AGENDA Historic Preservation Board Meeting

RE: CERTIFICATE OF APPROPRIATENESS 2024-COA-06 CONSTRUCTION

OF A NEW SINGLE-FAMILY RESIDENCE AT 805 EAST LEMON AVENUE (NORTHEAST CORNER OF SOUTH PRESCOTT STREET AND EAST

Francisco Valdez, owner of the subject property at the northeast corner of South Prescott Street and East Lemon Avenue (Alternate Key Number 1189811), is requesting Historic Preservation Board approval to construct a new single-family residence within the Washington Avenue Historic District.

Previous Floor plan (1 Story)

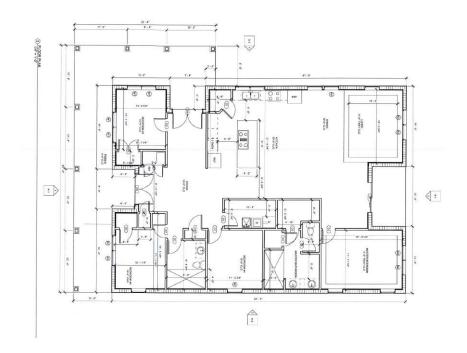
The previous design was a single-story of approx.2,311 sq.ft. and the width of the house was 49'-4".

Revised floor plans (2 Story)

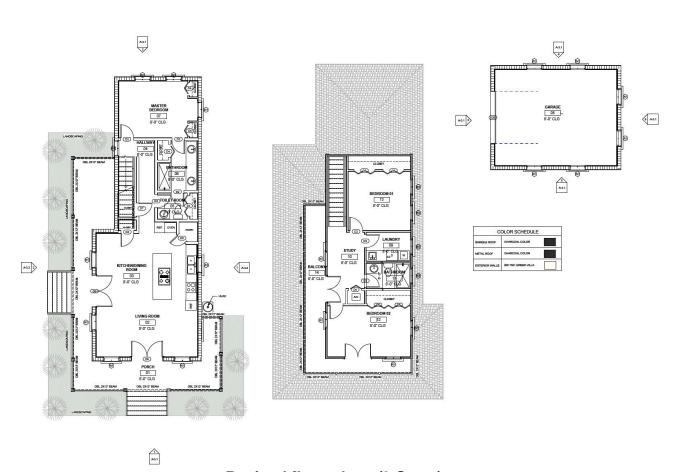
Homes in the frame vernacular style are typically rectangular and sometimes may be L-shaped to maximize cross ventilation. The proposed design floor plans is consistent with the architectural style.

Revised Elevations (2 Story)

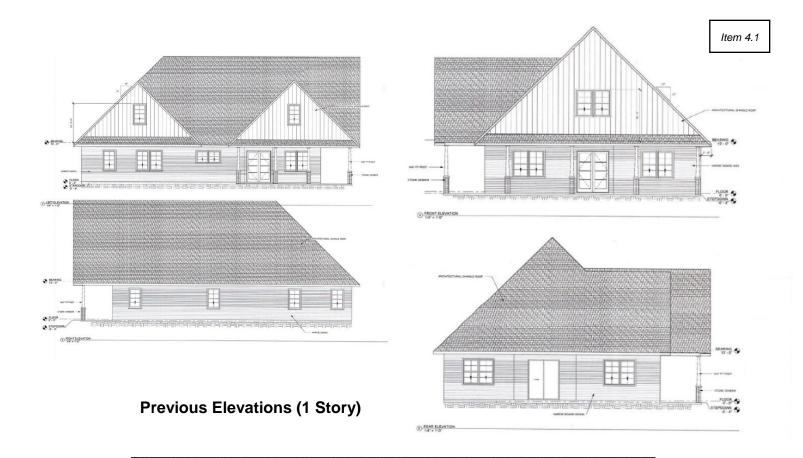
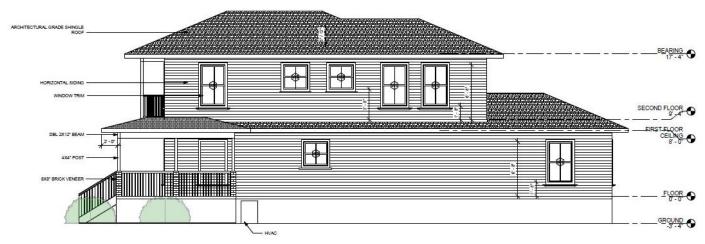
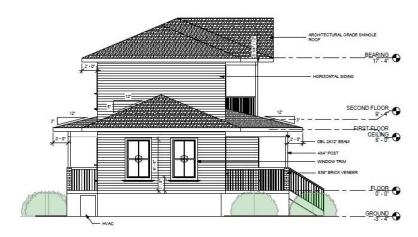
The proposed elevations are generally consistent with this. The proposed windows are making balance windows on elevations which is consistent with the neighborhood and the frame ventricular style.

The provided elevations show roof lines are generally consistent with this in the roof style provided.

The new designed elevations show a porch and balcony on first and second floor on both, side and front elevations, creating balanced elevations which is one of the most common features for frame vernacular architectural style.

The provided elevations show roof lines that reflect the typical design elements of the frame vernacular style. The roof line of the frame vernacular style is typically simple (hip or gabled) with deep overhanging eaves.

The proposed elevation's material is horizontal siding, Brick veneer and shingles for the roof, are all consistent with the common material for the frame vernacular architectural style and surrounding buildings.

Proposed Site Plan

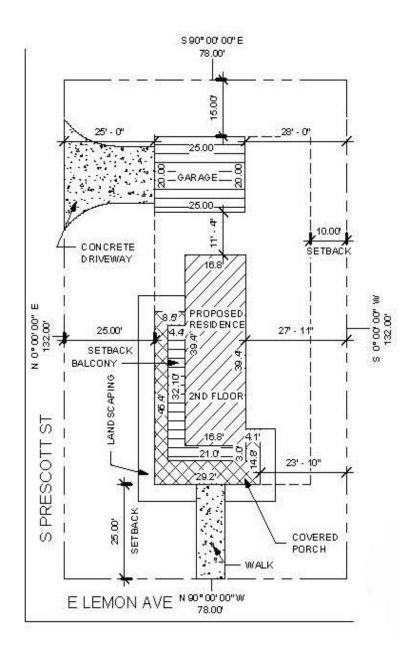
The building lot type for this property is designated as an "Estate lot":

- ✓ Minimum required street setbacks of 25 feet for both the front and left side facing the street.
- ✓ Minimum required common lot setback of 10 feet.
- ✓ Minimum required rear setback of 15 feet.
